Sydenham to Bankstown Metro

Submission on Preferred Infrastructure Report

Endorsed by Council 24 July 2018

Figure 1. Key principles to guide design of Bankstown Station.

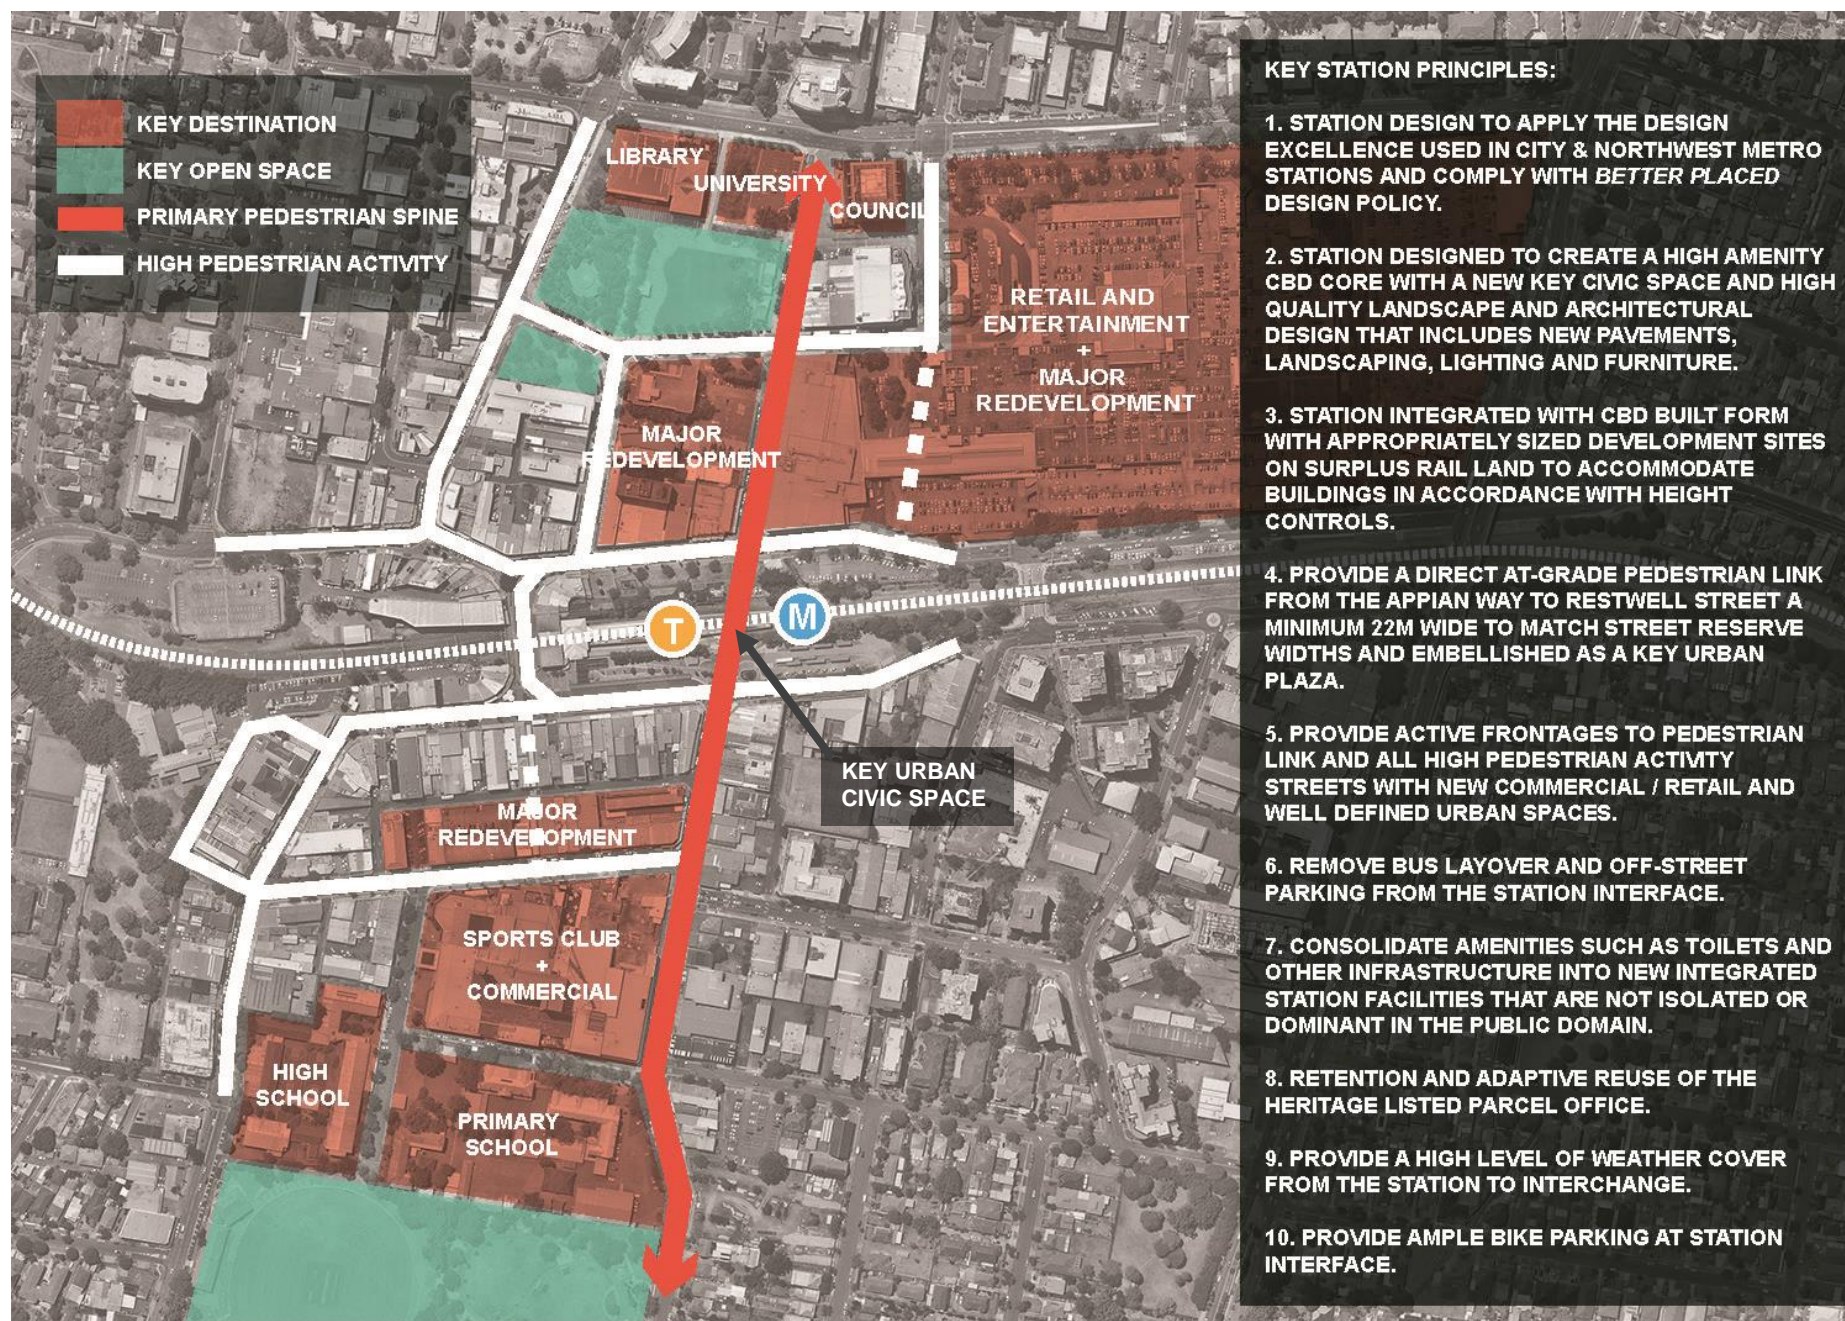
While we welcome long term planning for Bankstown, it is a greater priority to establish a Working Group to urgently redesign the Bankstown Metro Station to ensure that if longer term aspirations are not included the station still incorporates some fundamental design and connectivity outcomes in the short term.

Figure 1 sets out key principles that would need to be considered in an integrated station redesign whether underground or above.

Establish a Working Group with Council with clear terms of reference to urgently redesign Bankstown Station to a standard suitable for a major centre that is consistent with Better Placed; SEARS 14; the regional, district and transport plans; and key matters raised by Council.

Figure 2. Key principles to guide design of Campsie Station.

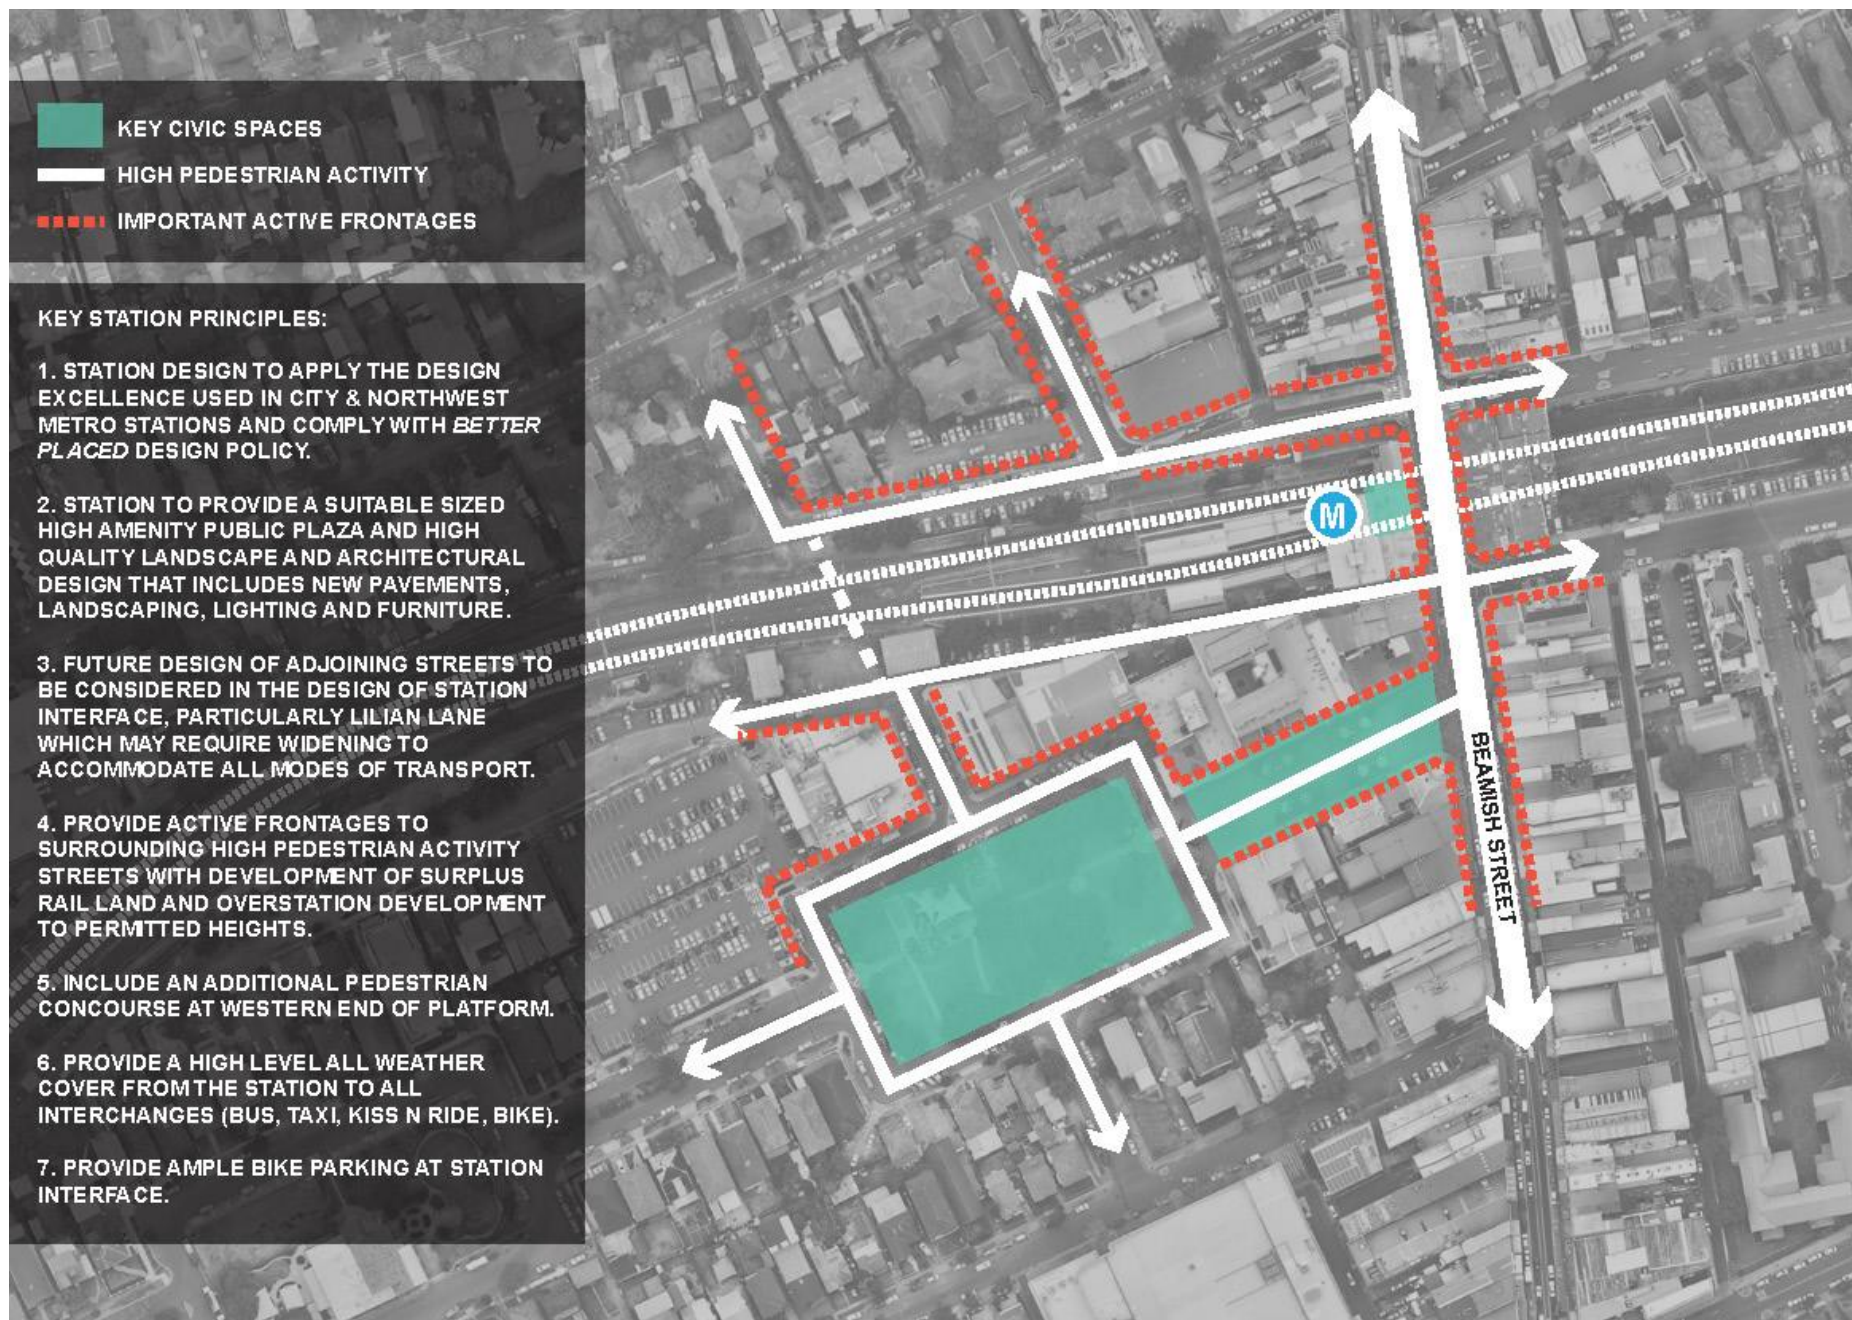
The design review should consider enlarging the public space for higher pedestrian activity and consider opportunities for over station development to concentrate activity and use the station precinct efficiently. Further recommended principles for the design of Campsie station are set out in Figure 2.

Establish a Working Group with Council with clear terms of reference to improve the design of Campsie Station and precinct to meet the future needs of this Strategic Centre in accordance with Better Placed and SEARs 14, and include consideration to larger public spaces and over station development.

Figure 3. Existing separated cycleways (green) and the active transport corridor (red).

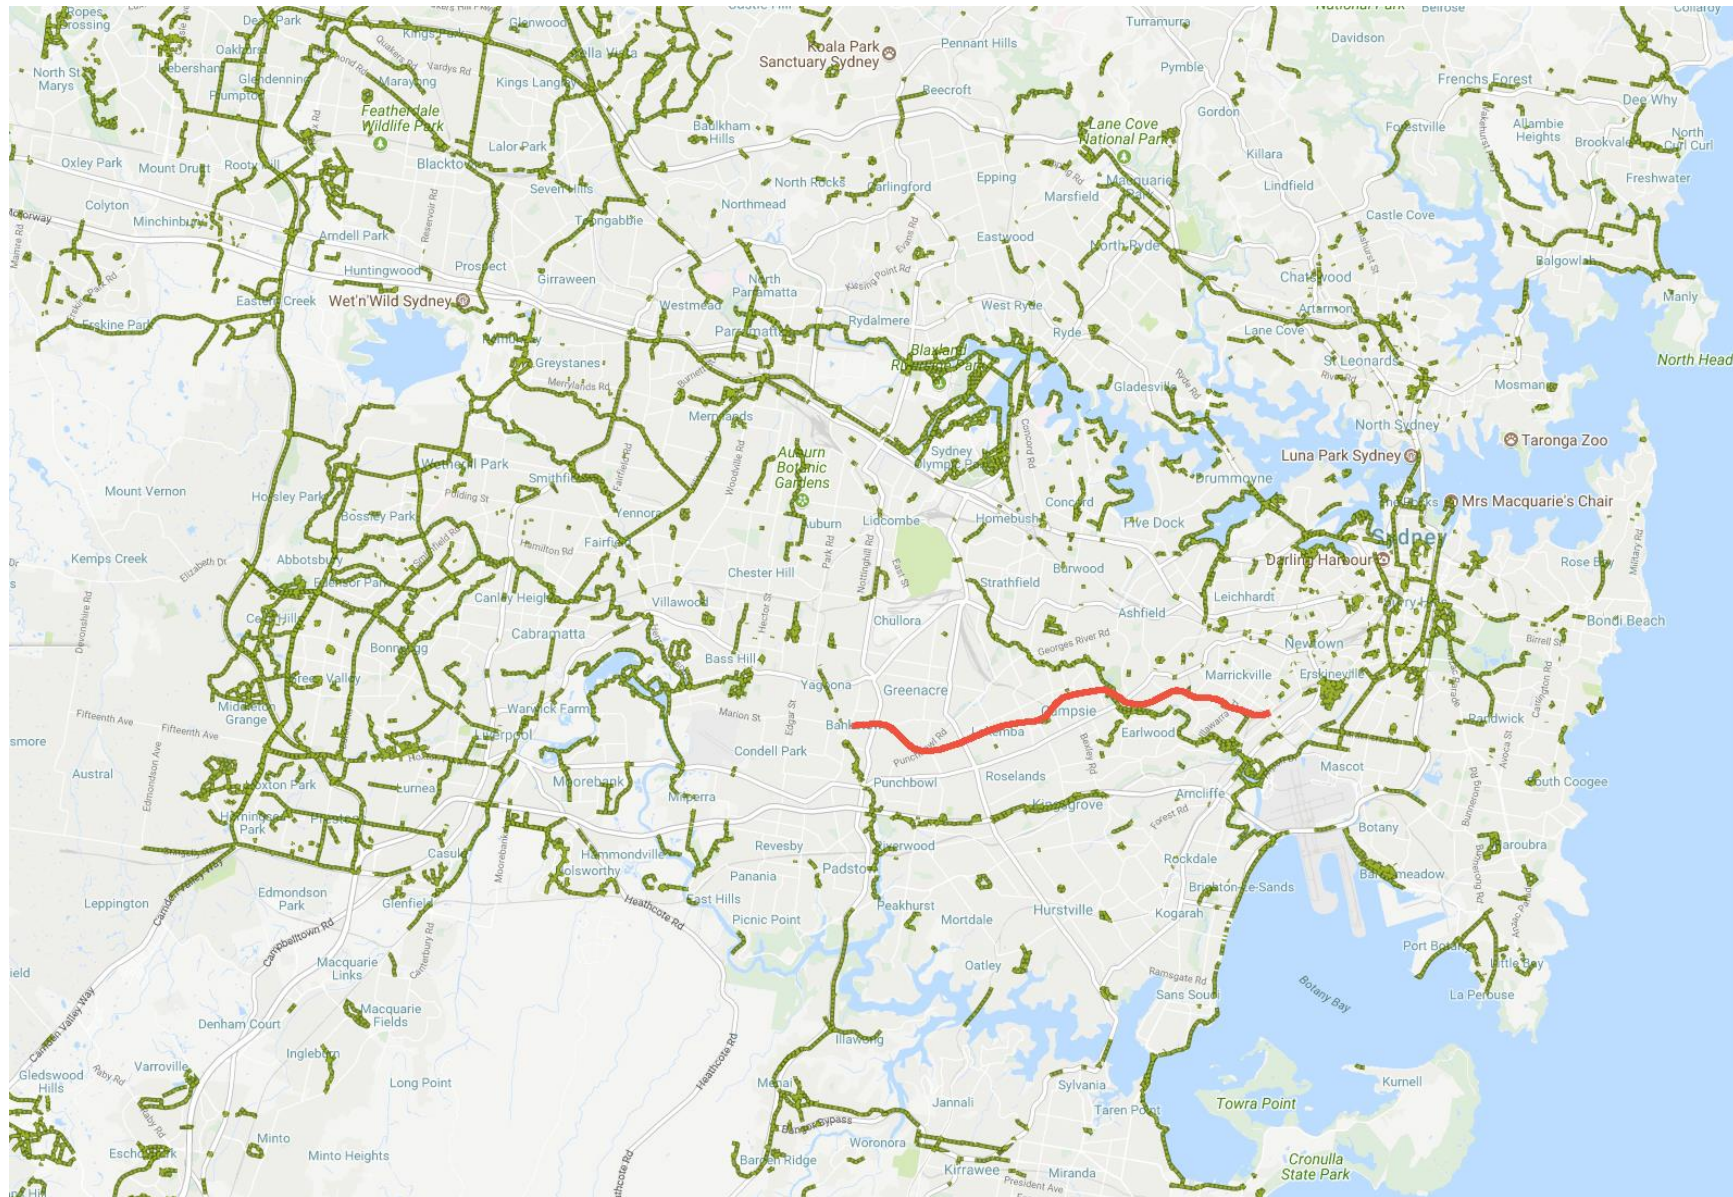
In promoting the Metro, the NSW Government made a commitment to an Active Transport Corridor (ATC) along the rail corridor from Bankstown to Sydenham, providing a much needed east-west linkage for cyclists and pedestrians. As illustrated in Figure 3, the ATC would connect through an area with one of the lowest number of separated cycleways in Sydney.

The EIS committed to building only the sections of the ATC within station precincts. The PIR has now discarded the entire ATC stating *“as the existing rail corridor is being utilised and not widened or changed as part of the preferred project, there would no longer be the space created to provide for an active transport corridor within the rail corridor”*. This is not true - the ATC did not require tracks to be realigned or the corridor widened and under the proposed concept there is still surplus land within the corridor suitable for the ATC. From a design perspective there is no reason the ATC couldn't remain as shown in the EIS.

The active transport corridor must be reinstated and delivered in its entirety as part of the project, or an alternative corridor be designed, funded and delivered as part of the project.

Figure 4. Connectivity across the Sydenham-Bankstown rail corridor.

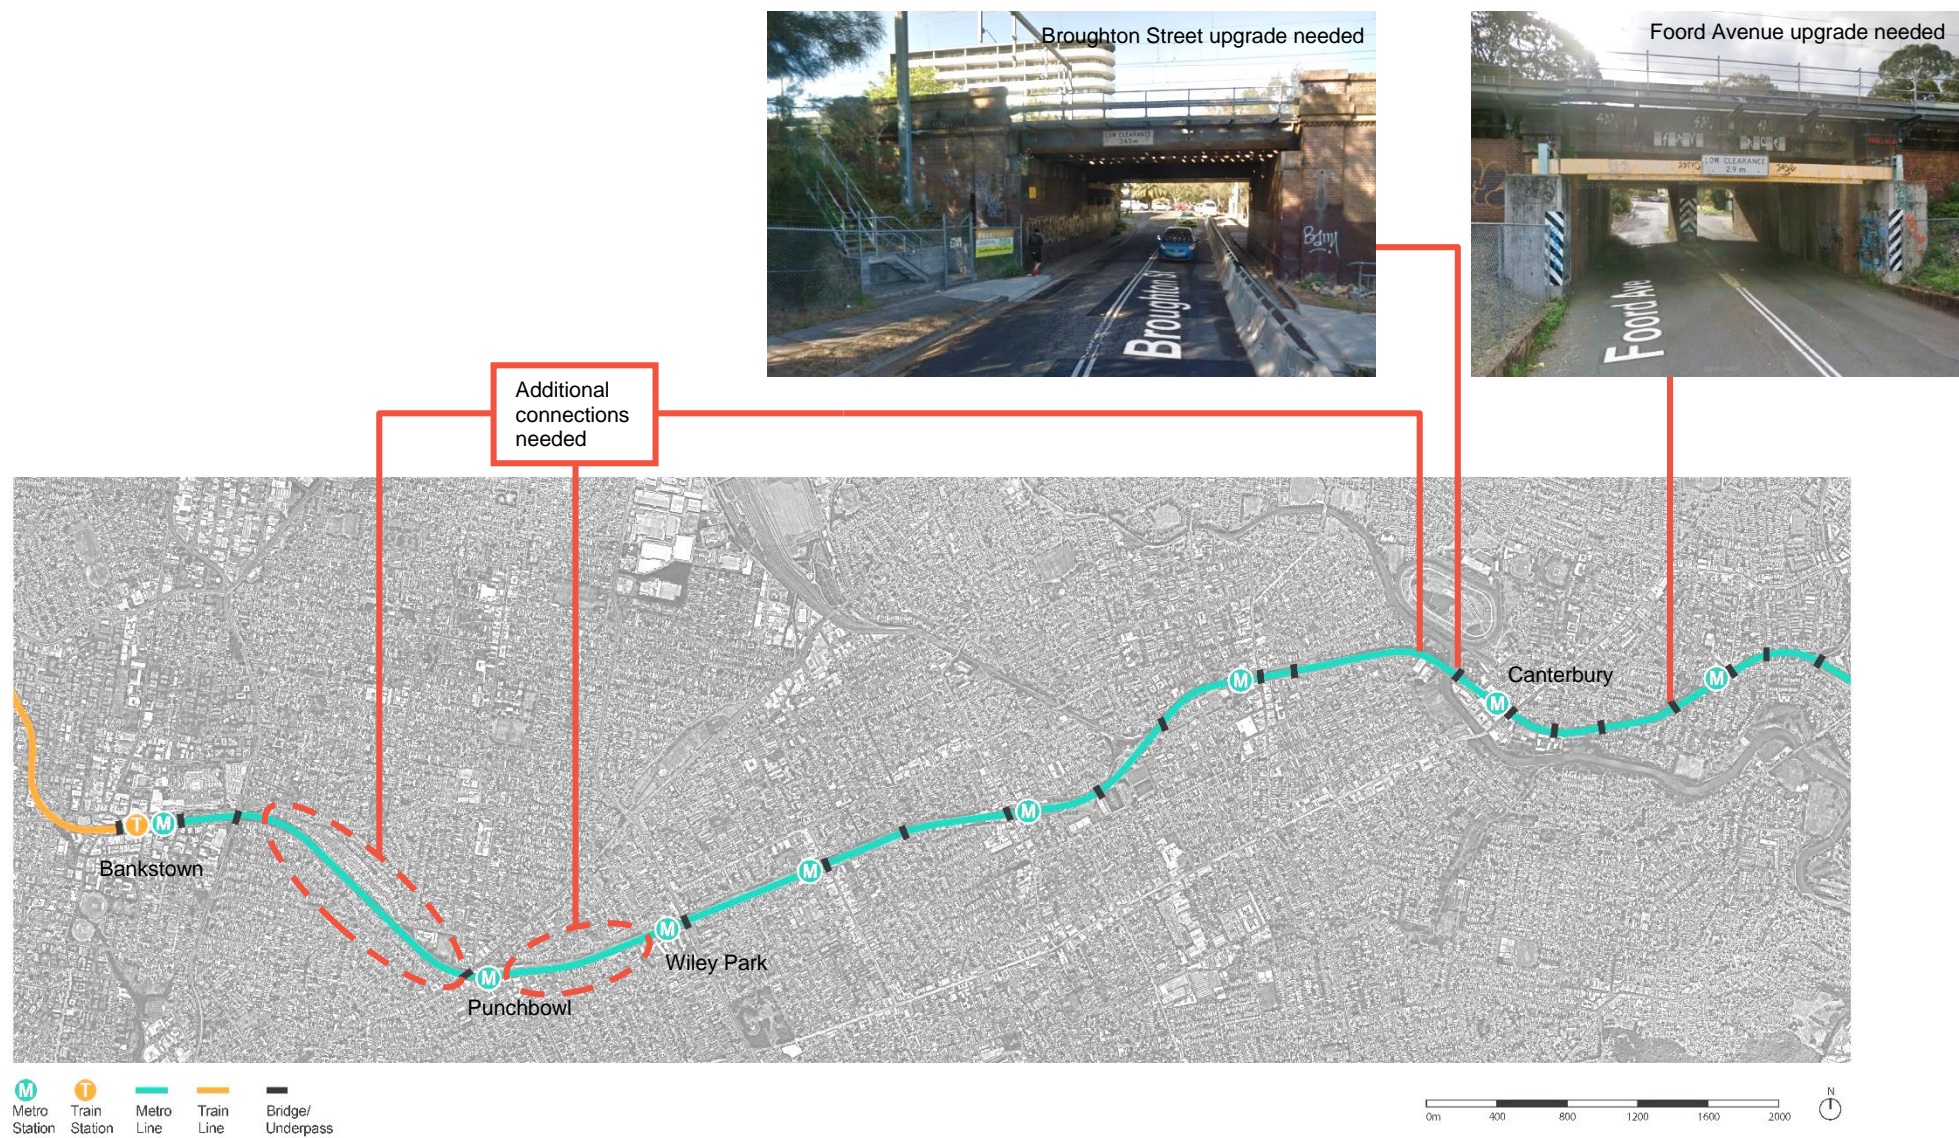
As highlighted in Figure 4, there are several long sections with no connectivity (eg. 1.6km between Bankstown and Punchbowl, 1.2km between Punchbowl and Wiley Park and between Tasker Park and Little Tasker Park).

The project must take this opportunity to include the upgrade of all overbridges and underbridges for all transport modes and ensure there is a rail crossing every 400m. This includes a new cross corridor connection between Bankstown and Punchbowl, between Punchbowl and Wiley Park and between Tasker Park and Little Tasker Park.

Figure 9. The project does not address four of the six state-wide outcomes in the *Future Transport Strategy* which are meant to guide planning and investment.

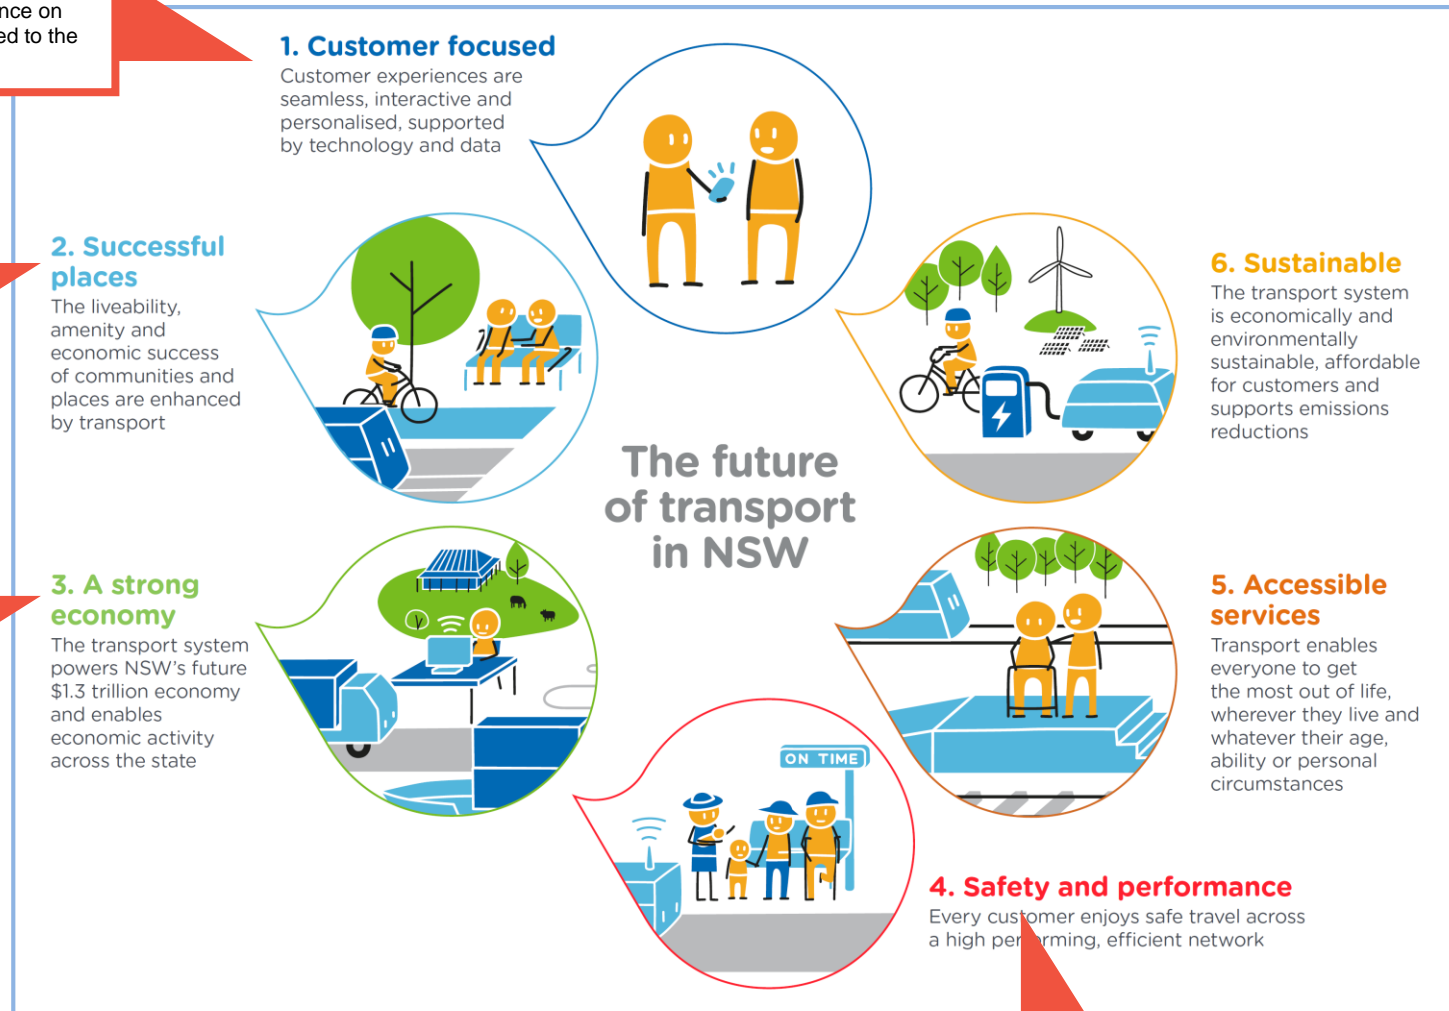
As highlighted in Figure 9 the PIR fails to address four of the six outcomes and confirms that the project is not consistent with the government's intent for more holistic and integrated transport planning.
